Model: Stinger-C1 DF (DF68)	Date: 15-Jan-00	No.: MA859001a
-----------------------------	-----------------	----------------

MB Correction

Model: Stinger-C1 DF	Date: 15-Jan-00	No.: MA859002a
----------------------	-----------------	----------------

Modified Article: Platen cover sheet pulls up on exposure glass		Prepared by: K. Miura	
From: Technical Services Dept., GTS Division			
Reason for Modification:	<input type="checkbox"/> Parts catalog correction <input type="checkbox"/> To facilitate assembly <input type="checkbox"/> Part standardization	<input type="checkbox"/> Vendor change <input checked="" type="checkbox"/> To improve reliability <input type="checkbox"/> Other	<input type="checkbox"/> To meet standards ()

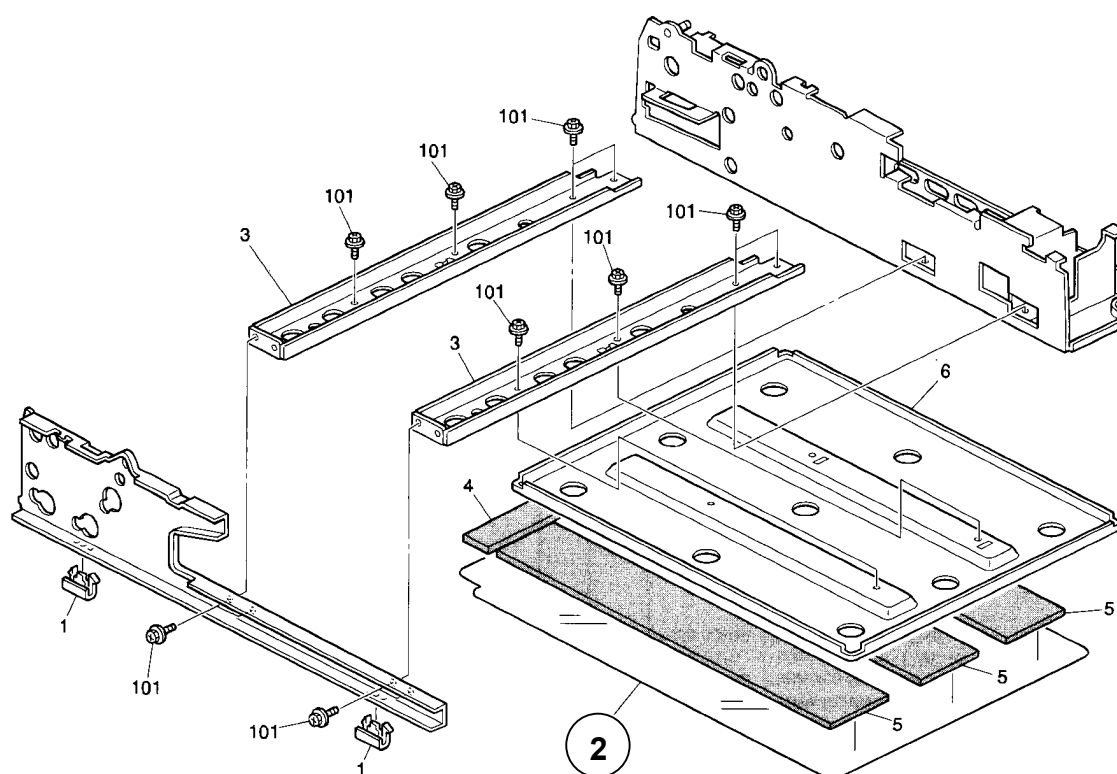
To standardize the platen cover sheet for several models, the following part has been changed:

Old part number	New part number	Description	Q'ty	Int	Page	Index	Note
A8593611		Sheet - Platen Cover	1		15	2	
	G4123721	Platen Cover Sheet	1	X/O	15	2

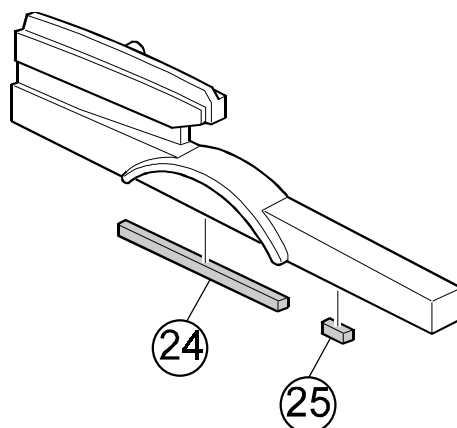
The following protective padding has been added to facilitate easier handling of the Platen Cover sheet.

New part number	Description	Q'ty	Page	Index	Note
A8584871	Cover Sponge - Front	1	3	24	
A8584872	Cover Sponge - Front Right	1	3	25

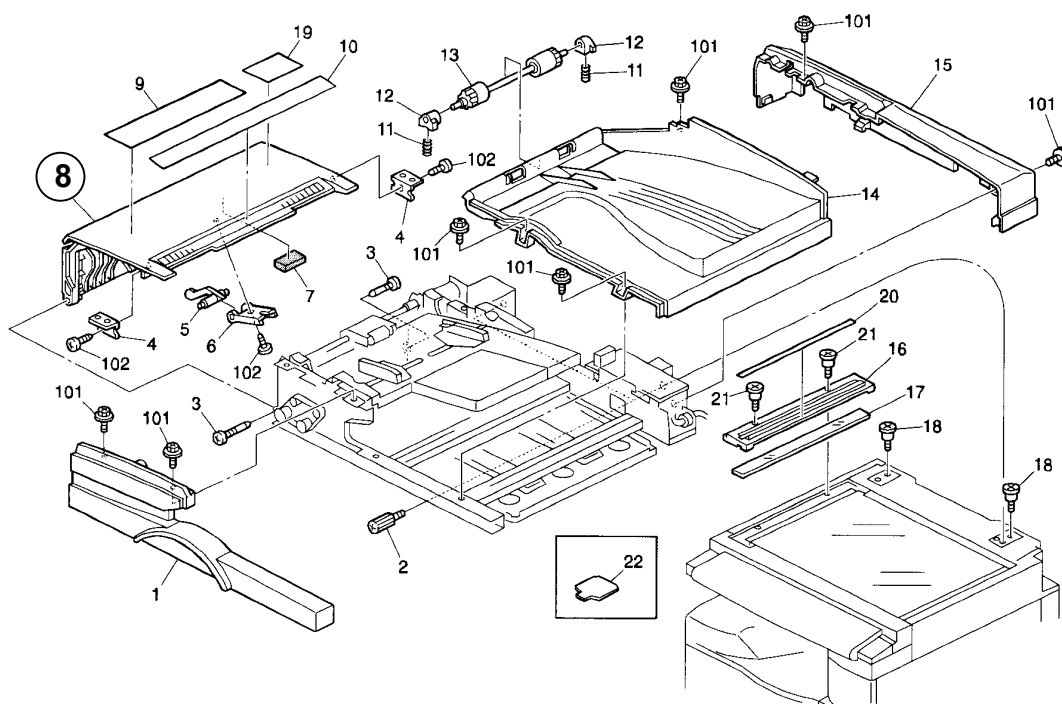
When the document approaches the transport rollers, it can sometimes contact the pullout lever due to warping in the left cover. The left cover has been changed to reduce the possibility of this happening.

Old part number	New part number	Description	Q'ty	Int	Page	Index	Note
A8594841	A8594842	Left Cover	1	X/O	3	8

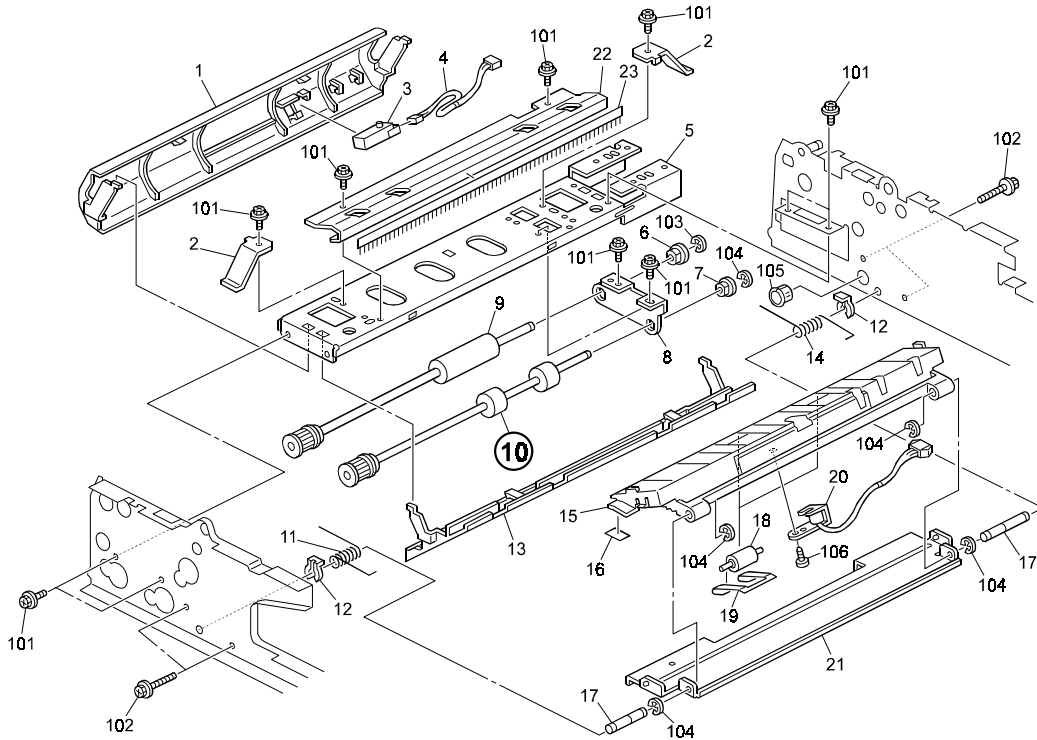
The following has been changed due to a vendor change.

Old part number	New part number	Description	Q'ty	Int	Page	Index	Note
A8593120	B3863121	Transport Roller - Middle	1	O/O	11	10

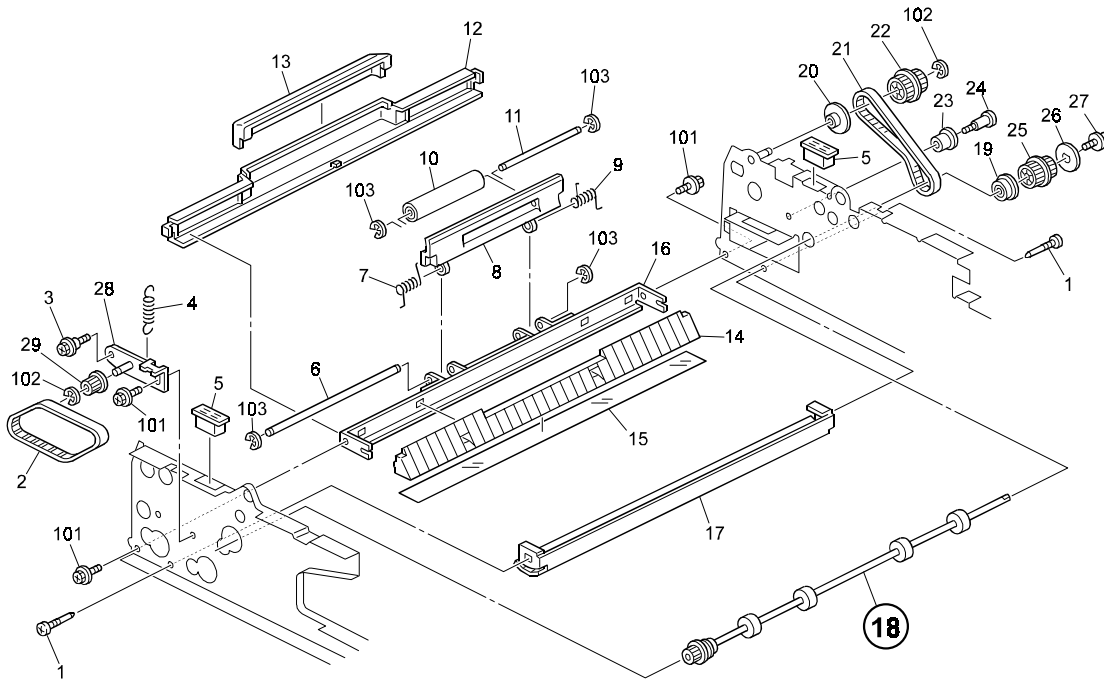
To minimize vibration of originals during paper feed, the following has been changed:

Old part number	New part number	Description	Q'ty	Int	Page	Index	Note
A8593130	B3863130	Exit Roller - Drive	1	O/O	9	18

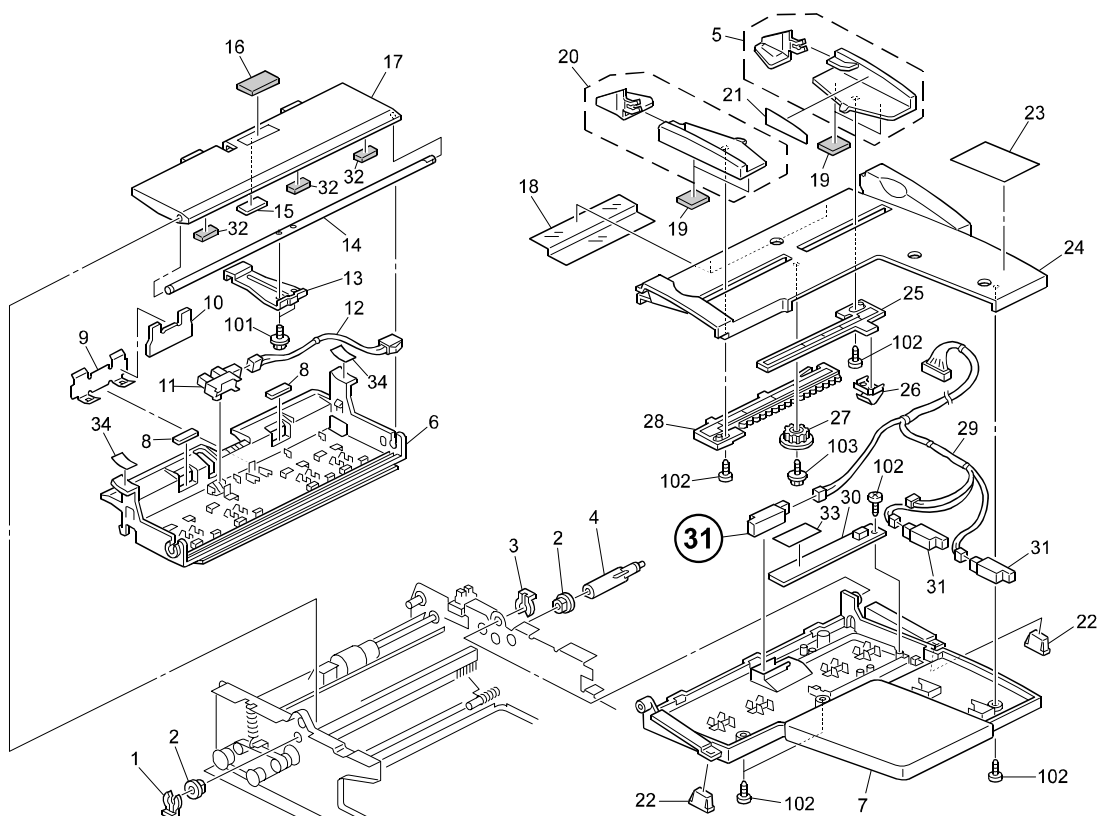
Please correct your Parts Catalog as follows:

Part number	Description	Old Q'ty	New Q'ty	Page	Index	Note
AW010087	Photo Sensor - A'ssy	2	3	5	31

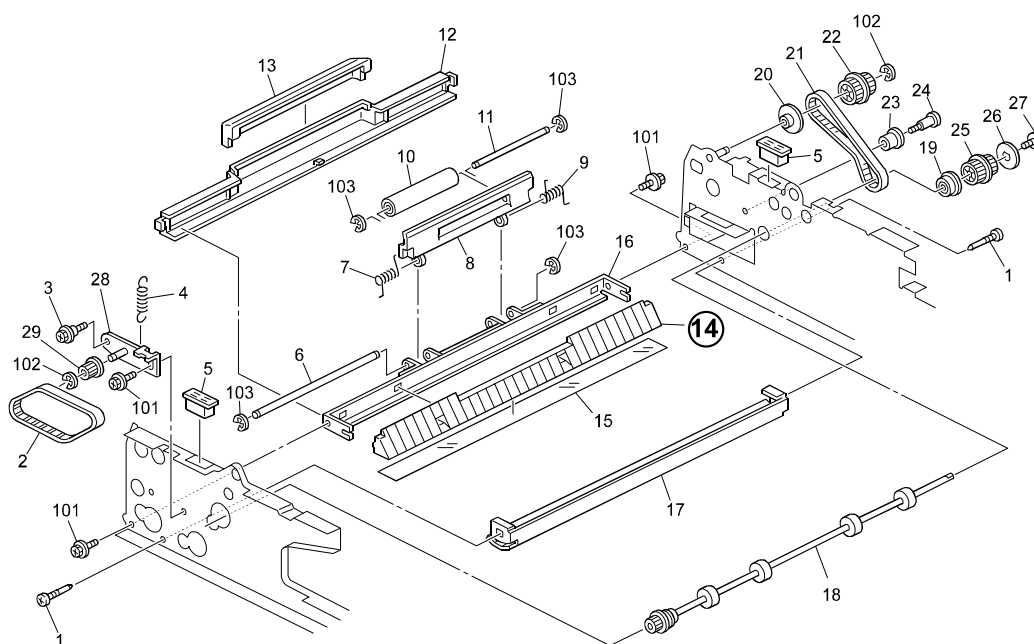
To ensure the junctions of the Lower Left Guide stay properly in position when the ADF is installed, the guide has been changed.

Old part number	New part number	Description	Q'ty	Int	Page	Index	Note
A8591721	A8591723	Left Lower Guide	1	X/O	9	14

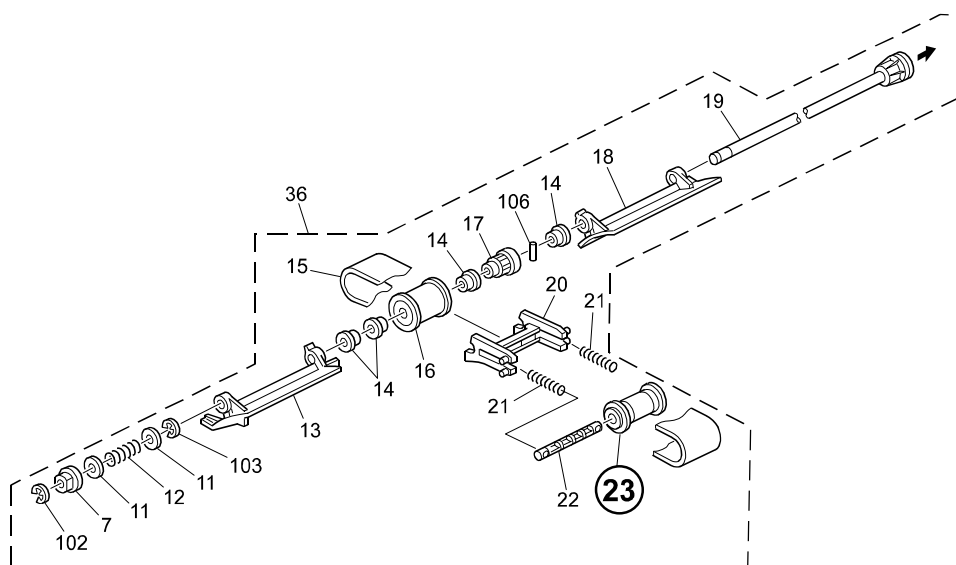
The following has been changed due to parts standardization with other models.

Old part number	New part number	Description	Q'ty	Int	Page	Index	Note
A8592113	B3872113	Drive Roller - Paper Feed Belt	1		7	23	
		Roller - Paper Feed Belt	1	O/O	7	23

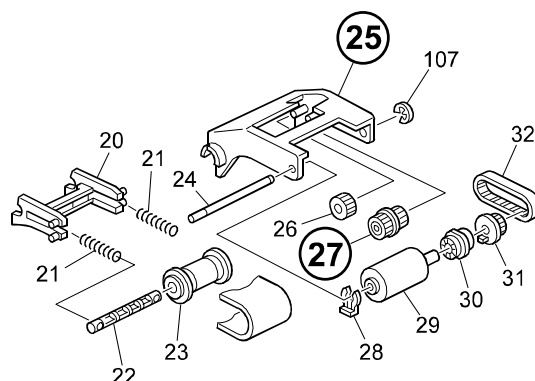
The following have been changed to further ensure that the shaft of the Pickup Holder for the Pulley is not damaged.

Old part number	New part number	Description	Q'ty	Int	Page	Index	Note
A8592151	G4123821	Holder - Pick Up	1	X/X	7	25	
A8592168	G4123831	Pulley - 22Z	1	X/X	7	27

Note: These parts must be replaced together as a set.
